Conceptual Review Agenda

Schedule for 03/10/14 to 03/10/14

Re: 412 Vine Dr - Office/lab

Description of project: This is a request to construct two buildings for office/laboratory use at 412 East Vine Drive (Parcel #s 97013-00-062, 97122-00-008, 97013-08-001, 97013-06-001 & 97013-06-002). The existing structures on site would be removed and two, 3-story buildings constructed in their place. Each building would be approximately 30,000 to 40,000 square feet. The site is located in the Community Commercial - North College (C-C-N) Zone District. Office/laboratory uses are subject to Administrative (Type 1) review.

SHEET TITLE:
SITE

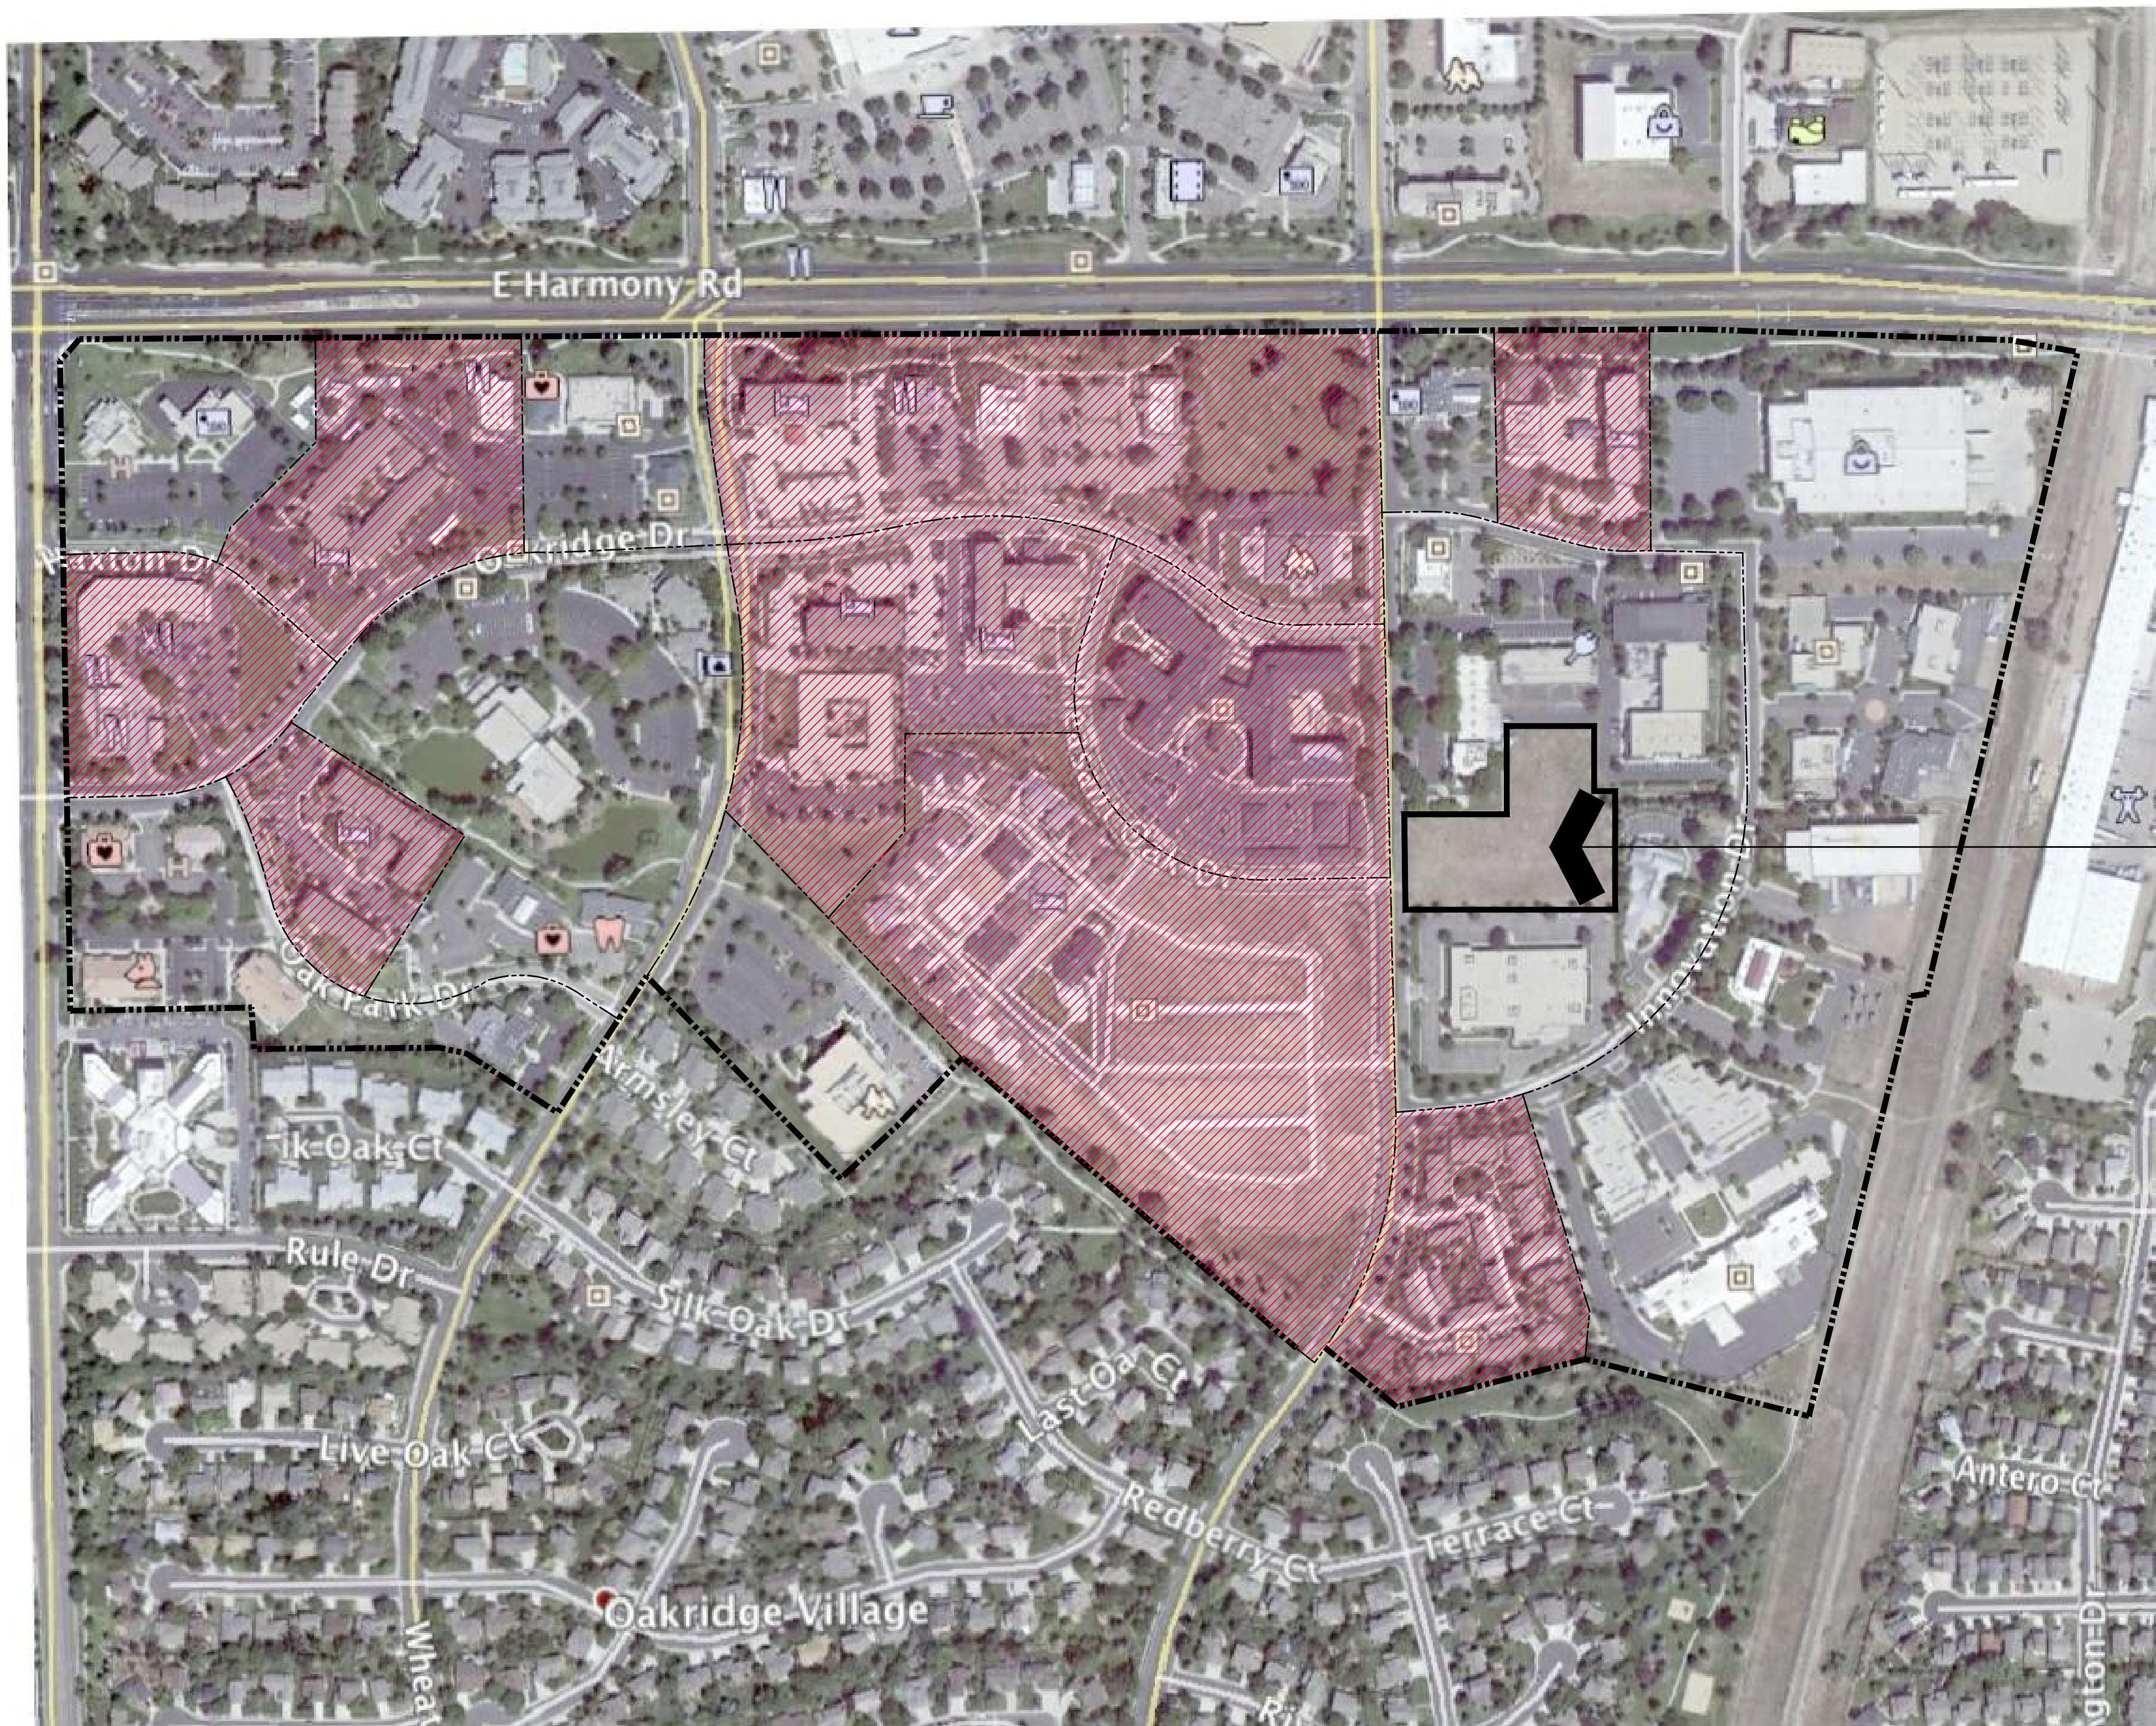
1. Secondary uses, including multifamily, are limited to 25% of the gross area of a larger employment-based development plan in the Harmony Corridor Zone District. In addition, the Oakridge Business Park Overall Development Plan, approved in 2000, designates this parcel for primary uses.

As it appears a secondary use at this location exceeds the 25% threshold, both a modification of standard and amendment of the Oakridge Business Park ODP will be required. An analysis of primary and secondary uses in the area should utilize the most-recent Oakridge Business Park ODP approved in 2000 as the baseline. Please note 3.18 acres of the Mackenzie Place development are classified as a primary use and the remaining 15.65 acres as a secondary use.

Based on a preliminary analysis, staff cannot support a modification increasing the amount of secondary uses in Oakridge. We would welcome and investigate additional data and analysis on the amount of primary and secondary uses and the remaining availability of sites for employment uses.
